PRODUCT/PROCESS CHANGE NOTICE (PCN)

PCN #: **TB0605-05** DATE: **7/01/06**

Product Affected: **CVBGA 52L & 56L Products**
shipped in tray

Existing Shipping Tray

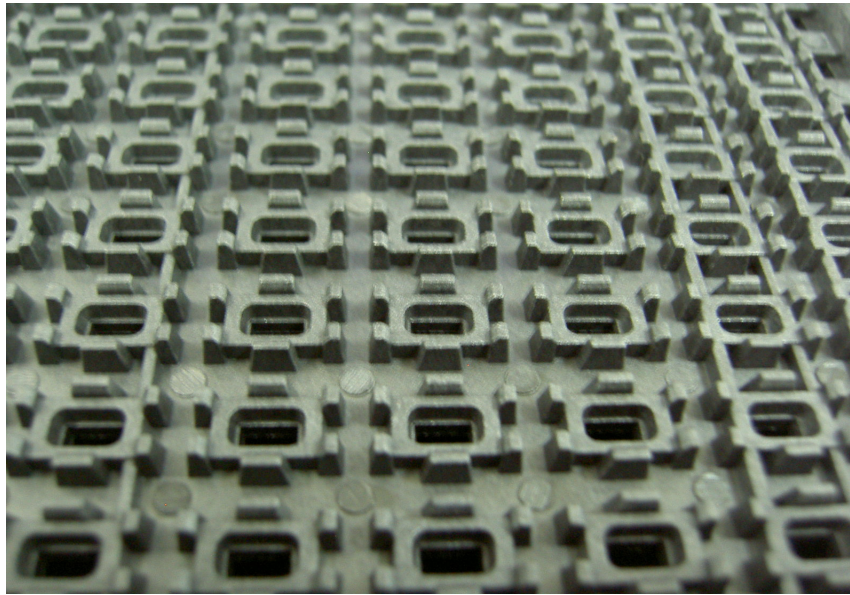
Please note that there will be a change in number of units per tray from 325 to 364 units/tray. There is no change in the tray dimensions.

Description	Existing Shipping Tray	New Shipping Tray
Part Number	12C-4570-E19	1QG-4570-F19
Tray Matrix	13x25	14x26
Qty per Tray	325 units	364 units
Pocket Size (WxL)	4.67x7.17 +/- 0.08mm	4.64x7.14 +/- 0.08mm

New Shipping Tray

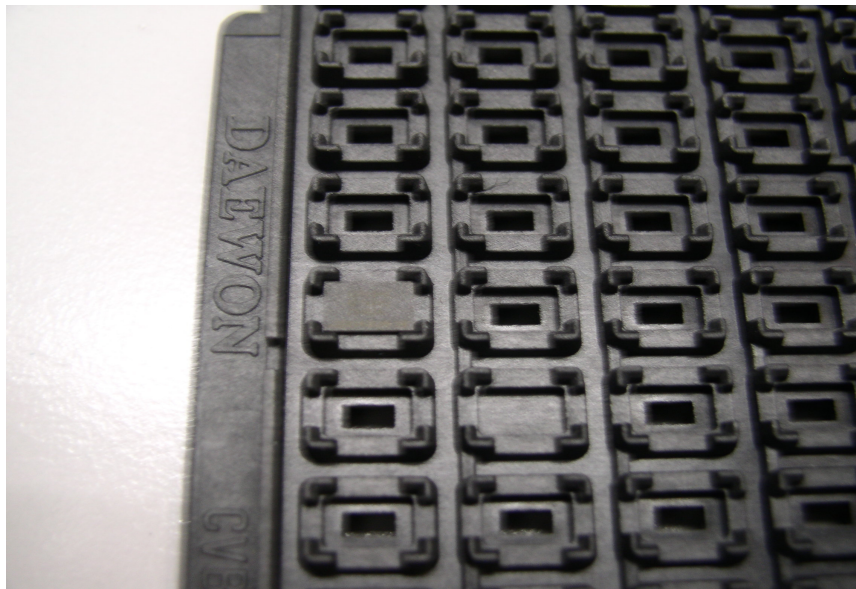
Detail of Change: This notification is to advise our customer that IDT has qualified new shipping trays for CVBGA 52L and 56L products. The new trays provide better protection during product shipment.
